MONITORING YEAR 1 ANNUAL REPORT

LONE HICKORY MITIGATION SITE

RE: Lone Hickory Mitigation Site – Monitoring Year 1 Report Final
Yadkin River Basin – CU# 03040101 – Yadkin County
DMS Project ID No. 97135
Contract # 006897

Wildlands Engineering, Inc. (Wildlands) has reviewed the Division of Mitigation Services (DMS) comments from the Draft Monitoring Year (MY) 1 report for the Lone Hickory Mitigation Site. Wildlands' responses to DMS' report comments are noted below in *italics*.

Figure 3.1 Integrated Current Condition Plan View Map (Sheet 1)
 Lone Hickory Mitigation Site
 DMS Project No. 97135
 Monitoring Year 1 - 2019

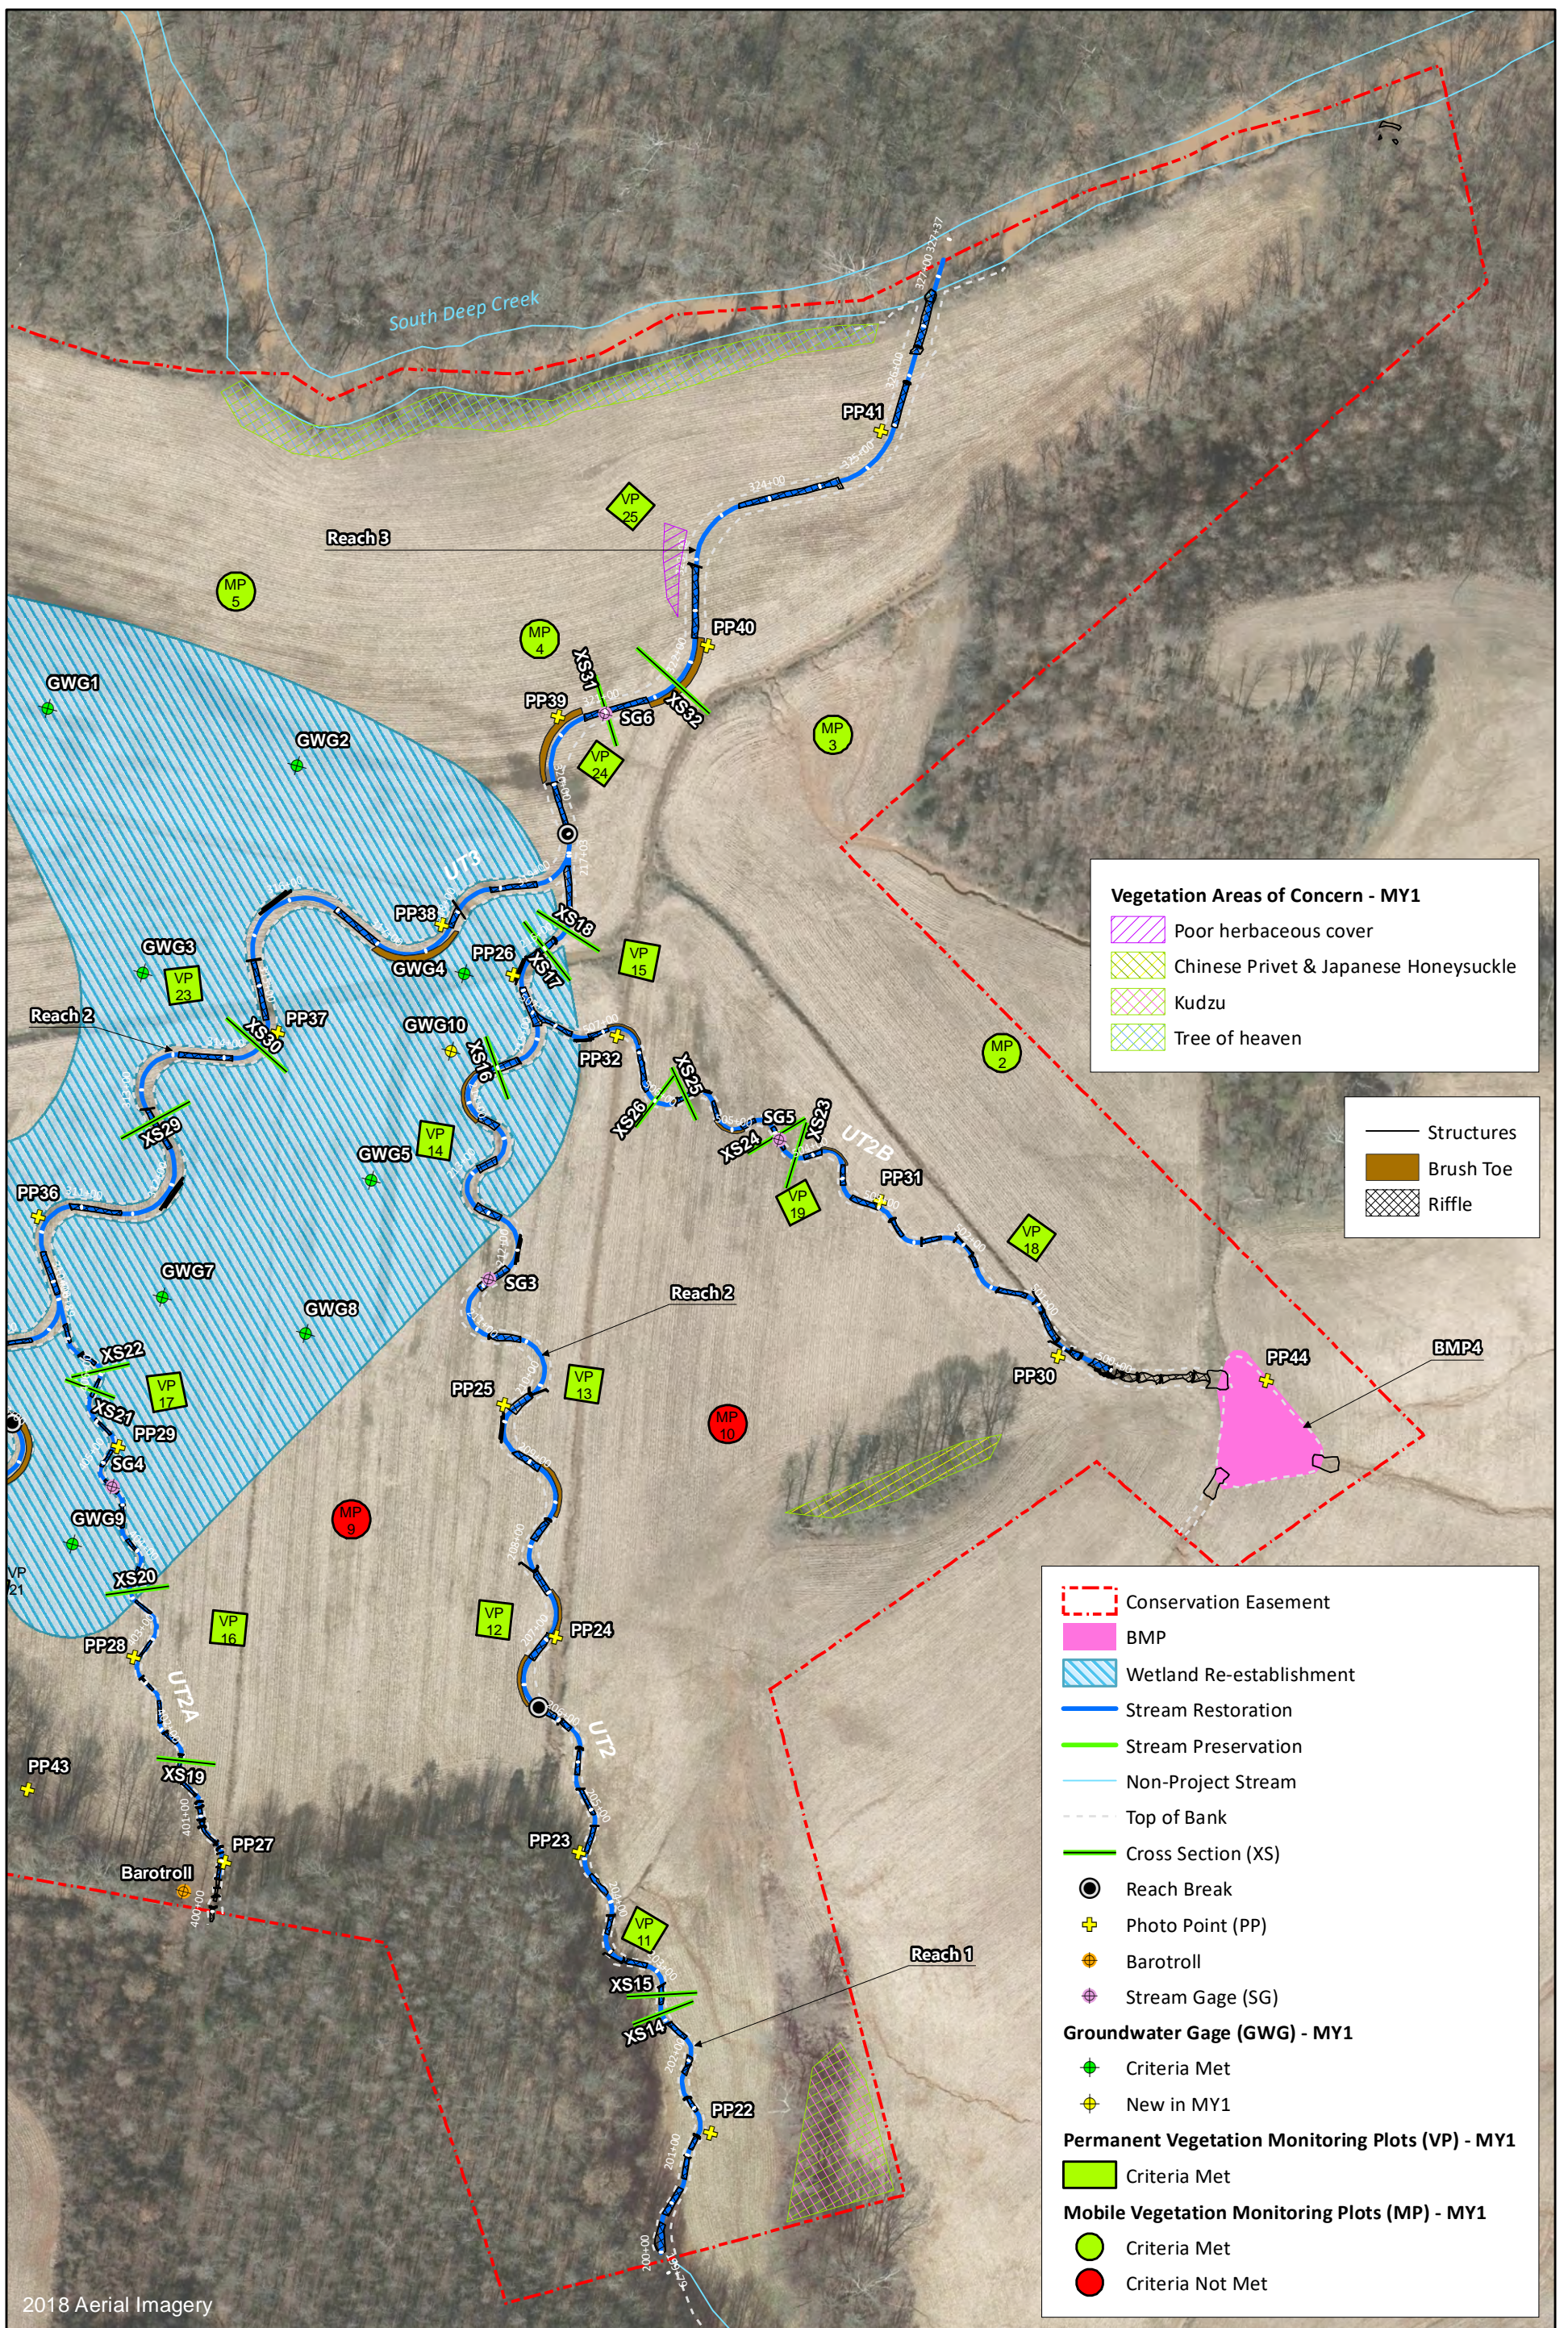
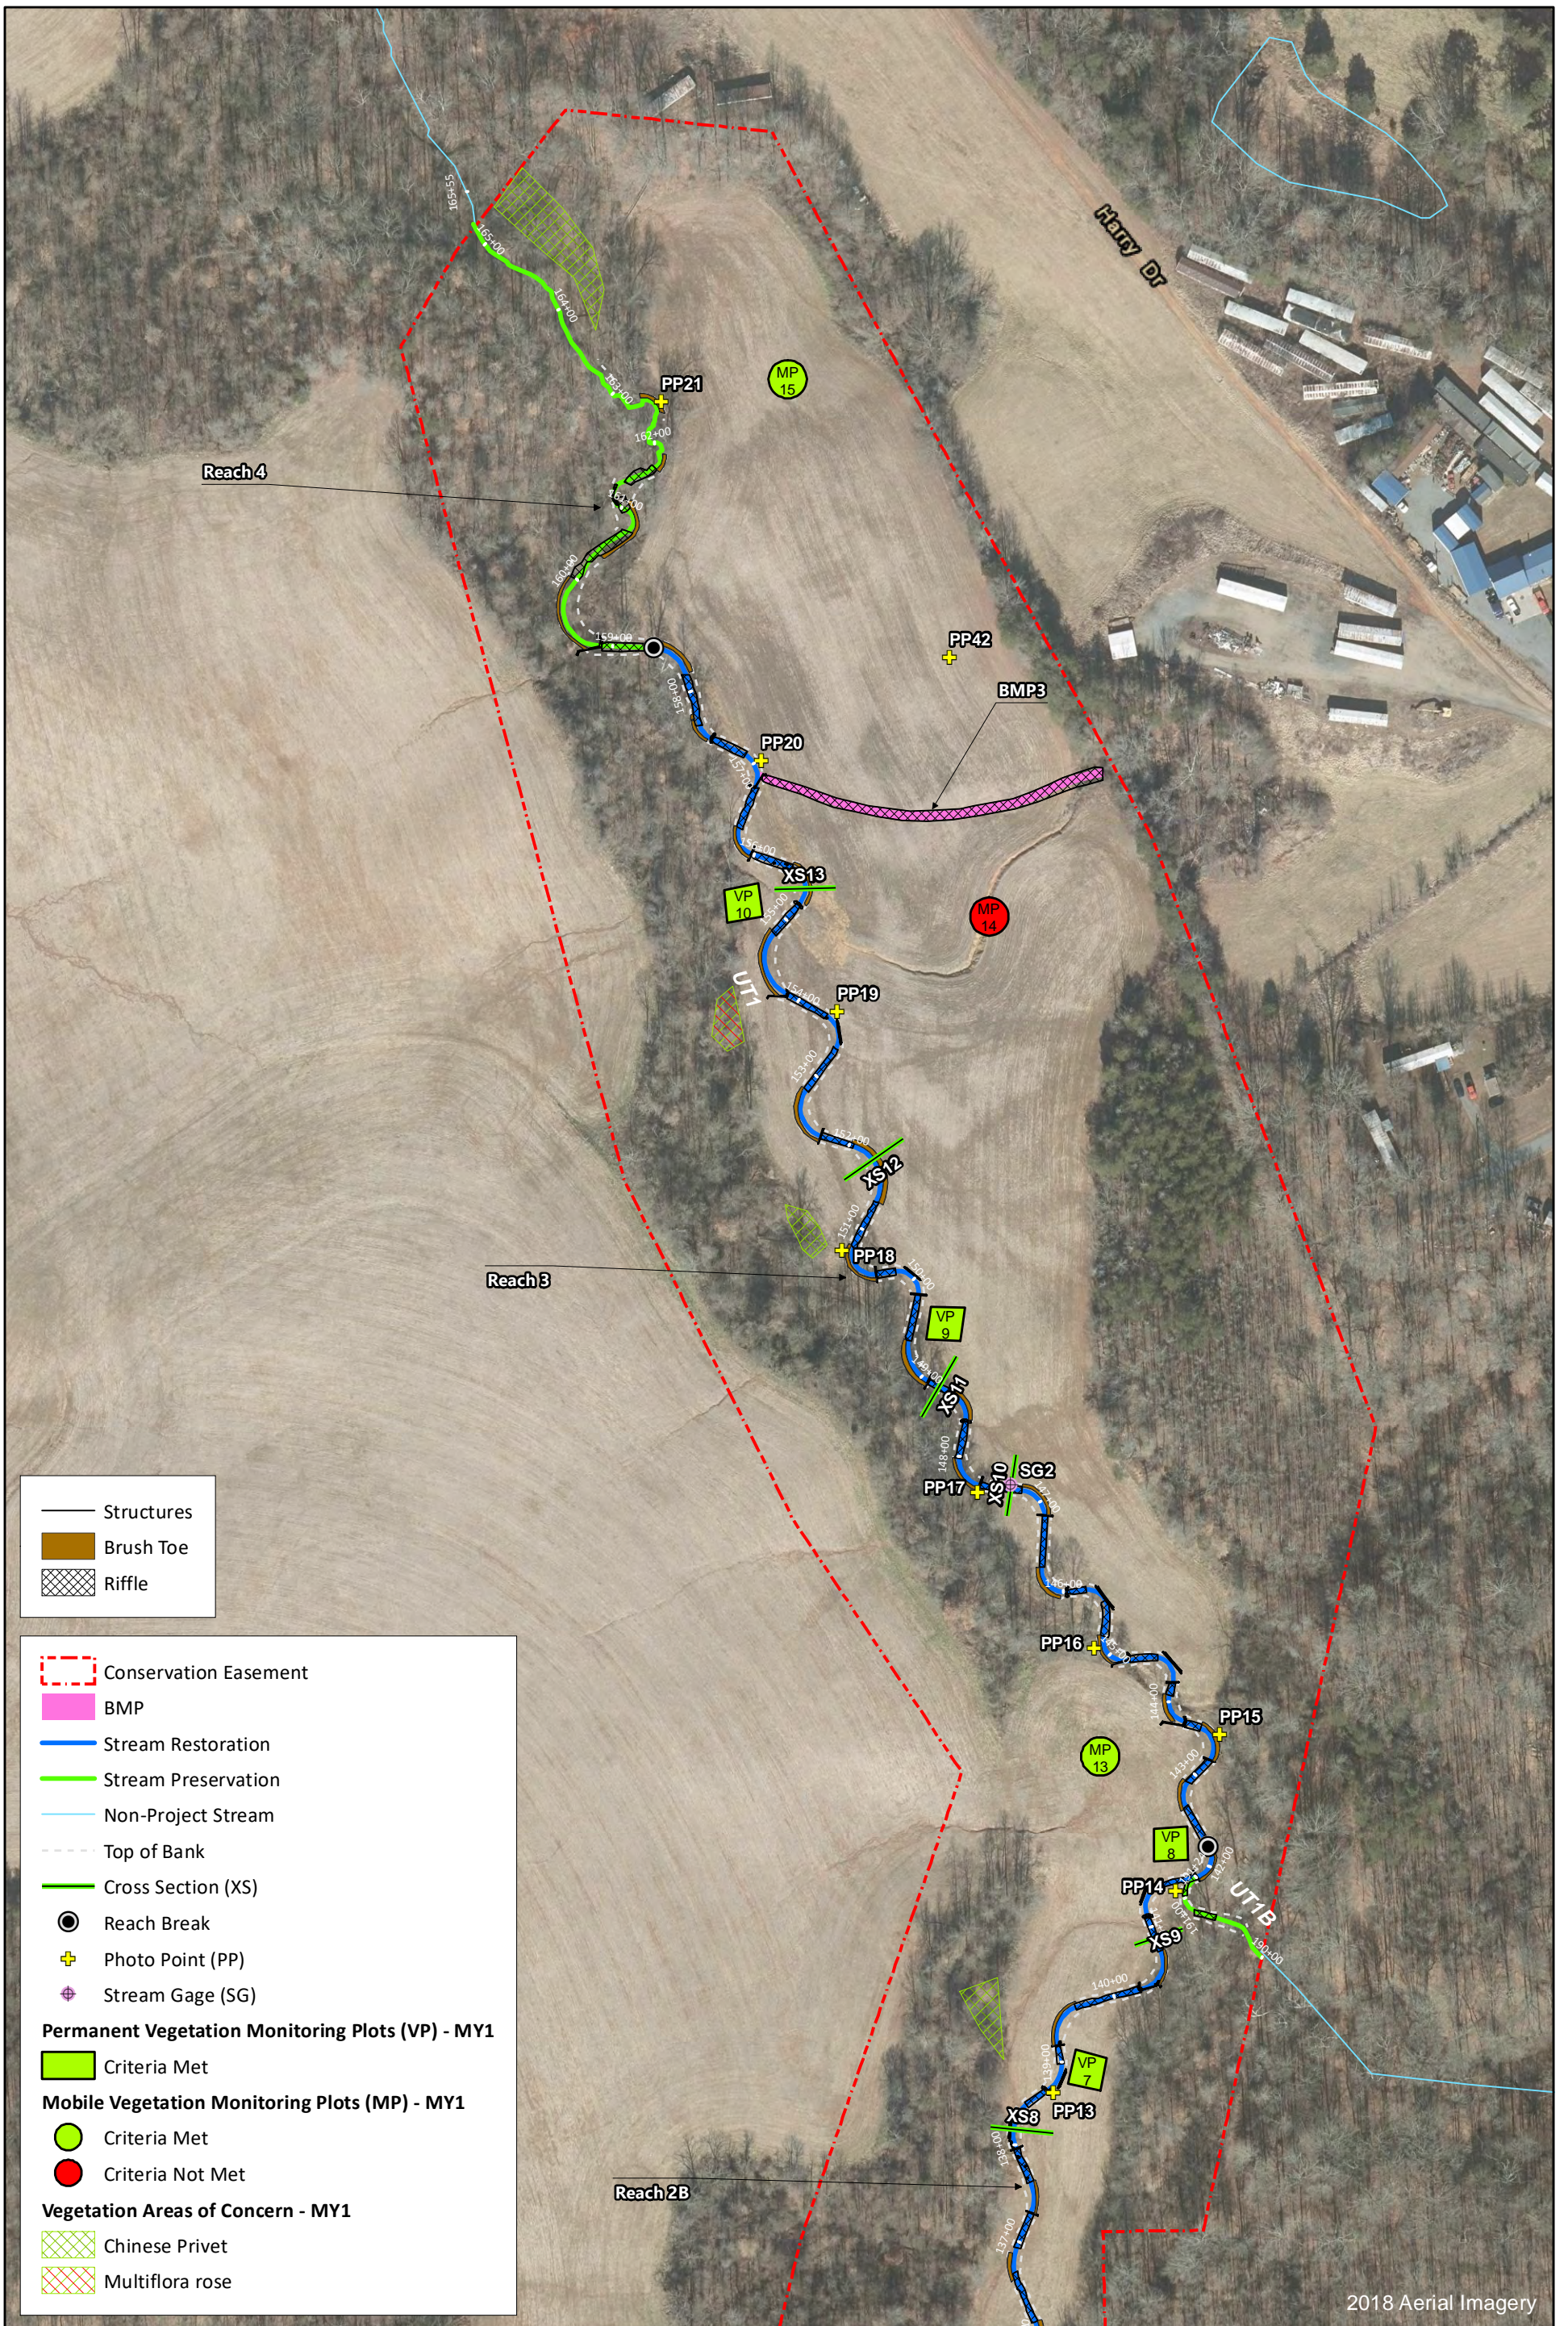
DMS comment; Section 1.2.4 – Stream Hydrology Assessment & CCPV Maps: Do the CCPV maps show the October 2019 relocated stream gages on UT2A and UT2B or the MY0-MY1 gage locations? Since these gages were not relocated until October 2019, DMS recommends showing the previous MY0 locations in the MY1 report and updating the mapped locations (and digital support files) in the 2020 - MY2 report. Please address and update the report text accordingly.

Wildlands response; The CCPV maps submitted with the MY1 draft report showed the relocated stream gage locations on UT2A and UT2B. The CCPV maps and digital support files have been updated to show the previous MY0-MY1 stream gage locations on UT2A and UT2B and text has been added to section 1.2.4. Going forward, the MY2 report will show the relocated stream gage locations.
